# FINAL ENVIRONMENTAL IMPACT REPORT

State Clearinghouse No. 98041003  
Santa Barbara County No. 01-EIR-5

## TAJIGUAS LANDFILL EXPANSION PROJECT

REVISED FIGURE 2-4

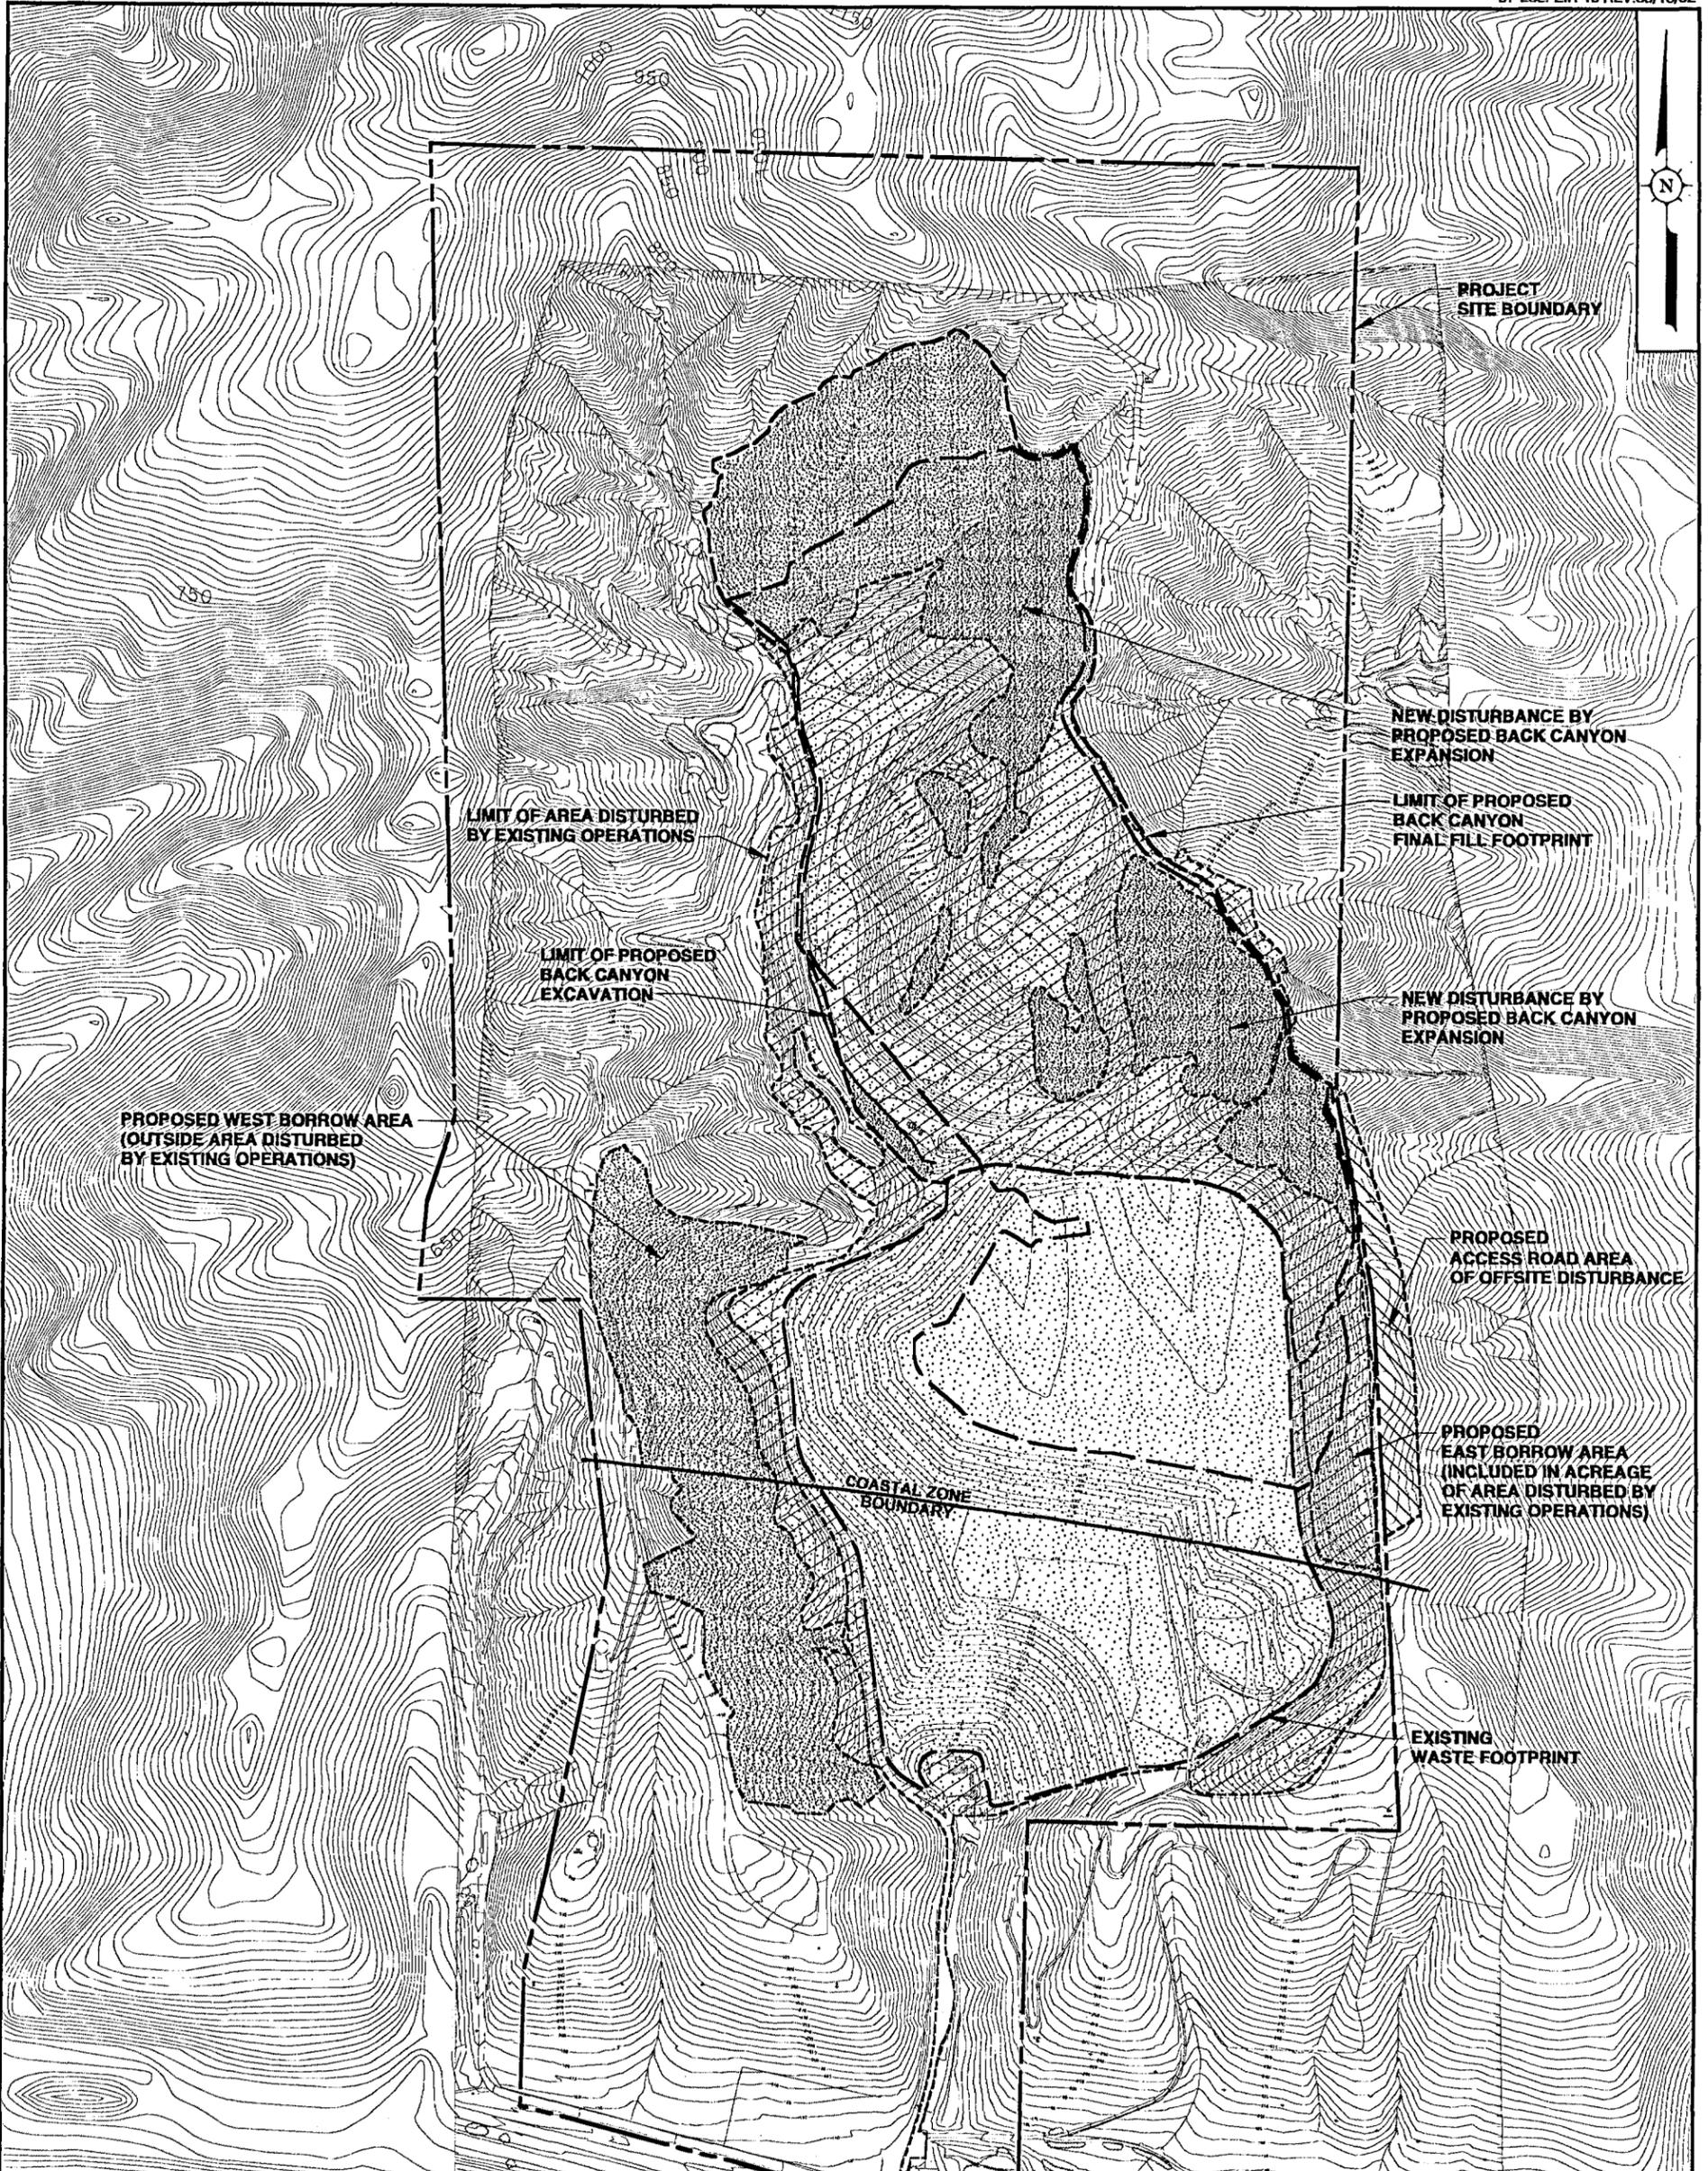
- 16-2 { 2. Page 1-40 Table 1-2, Section 3.4 First line needs correction from "in-change sedimentation basin" to *in-channel sedimentation basin*.
- 16-3 { 3. Page 2-11 Figure 2-4, Correct acreage of offsite disturbance to 5 acres from 3 acres.

- 16-4 { 4. Page 2-11 Figure 2-4, Include figure for total acreage of disturbance as indicated on Table 2-2, identifying the total 259 acres for the Front Canyon on the site plan.

Comment noted. The legend on Draft EIR Figure 2-4 has been changed to reflect 5 acres. See Revised Figure 2-4 in Final EIR Section 4.4.

Comment noted. The total acreage of disturbance for the Front Canyon is 259 acres. This has been included on Draft EIR Figure 2-4. See Revised Figure 2-4 in Final EIR Section 4.4.

NOTE:  
THIS FIGURE WAS REVISED BASED ON COMMENT  
NUMBERS 16-3 AND 16-4.

REVISED FIGURE 2-7

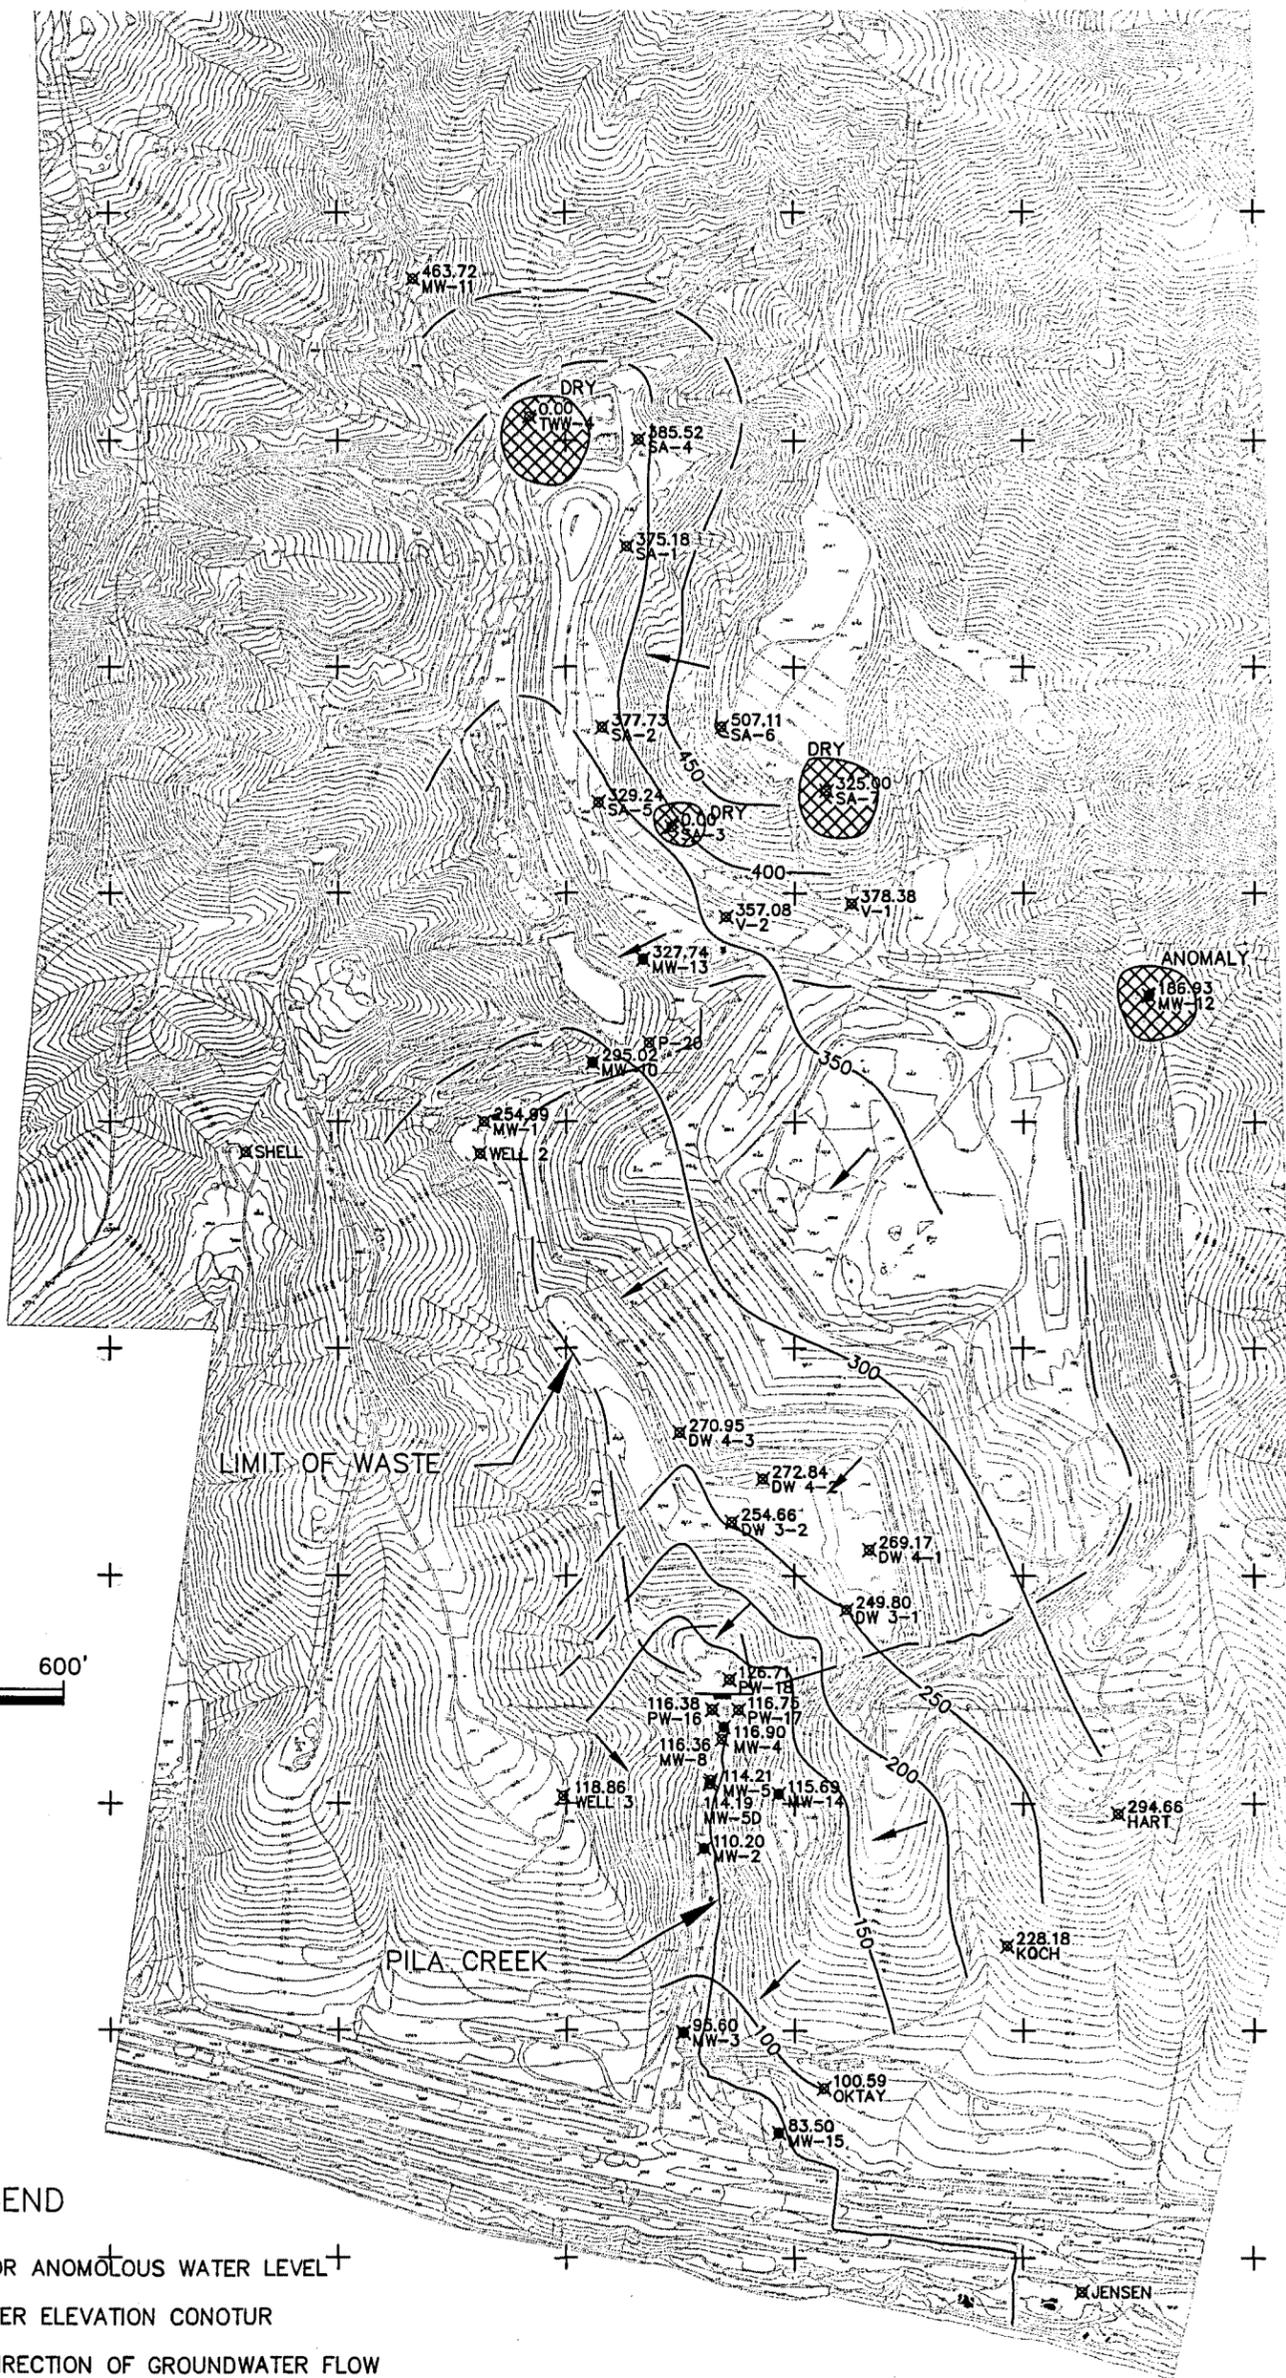
- 16-5 { 5. Page 2-19 Figure 2-7, Correct acreage of offsite disturbance to 5 acres from 3 acres.

- 16-6 { 6. Page 2-19 Figure 2-7, Include figure for total acreage of disturbance as indicated on Table 2-2, identifying the total 260 acres for the Back Canyon on the site plan.

Comment noted. The legend on Draft EIR Figure 2-7 has been changed to reflect 5 acres. See Revised Figure 2-7 in Final EIR Section 4.4.

Comment noted. The total acreage of disturbance for the Back Canyon is 260 acres. This has been included on Draft EIR Figure 2-7. See Revised Figure 2-7 in Final EIR Section 4.4.

NOTE:  
THIS FIGURE REVISED BASED ON COMMENT  
NUMBERS 16-5 AND 16-6.

**TRC** REVISED FIGURE 3.3-5

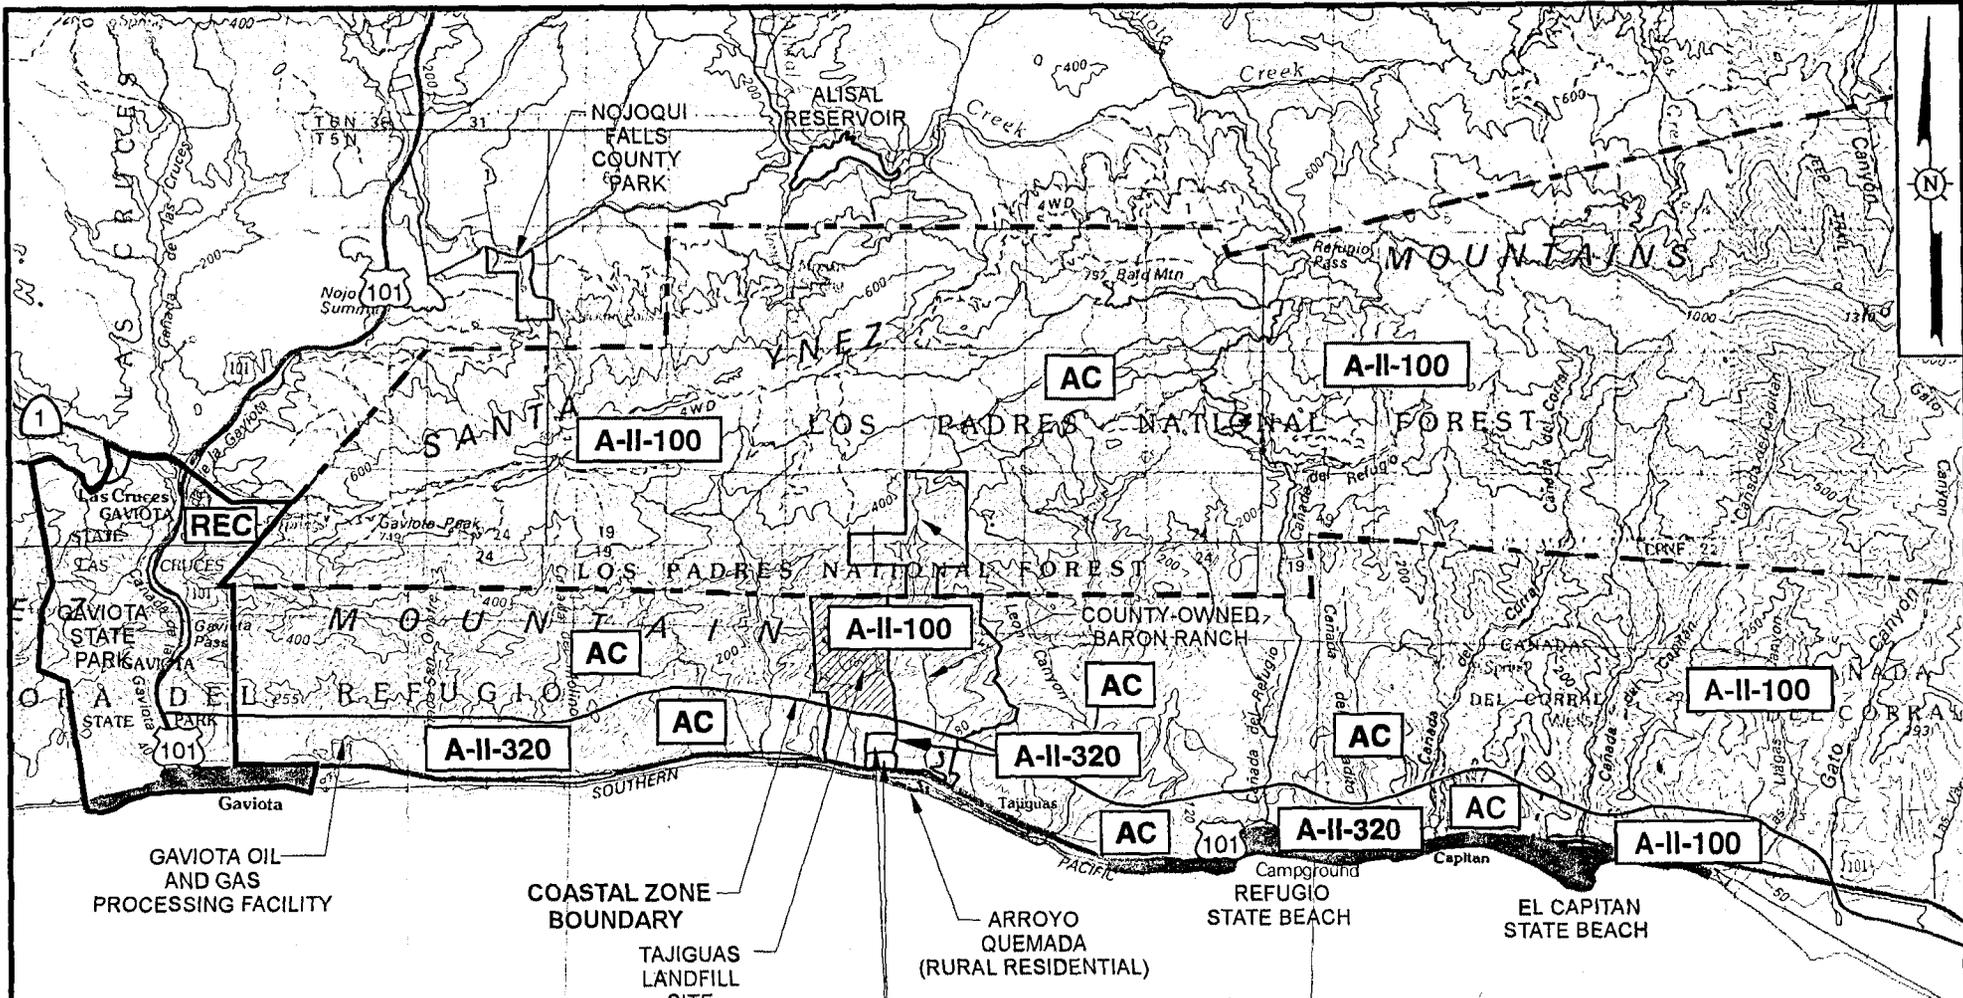
4-2 *TLC has requested the info about this well*  
Figure 3.3-5 There is a third water well not shown on this map, drilled in 1997. We can provide GPS coordinates and well data.

The GPS coordinates, as provided under separate cover by the Land Trust of Santa Barbara County for the third well on the Arroyo Hondo property, are 34.3802944 and -120.1415598. Draft EIR Figure 3.3-5 has been revised to show the third well. Please refer to Revised Figure 3.3-5 in Final EIR Section 4.4.
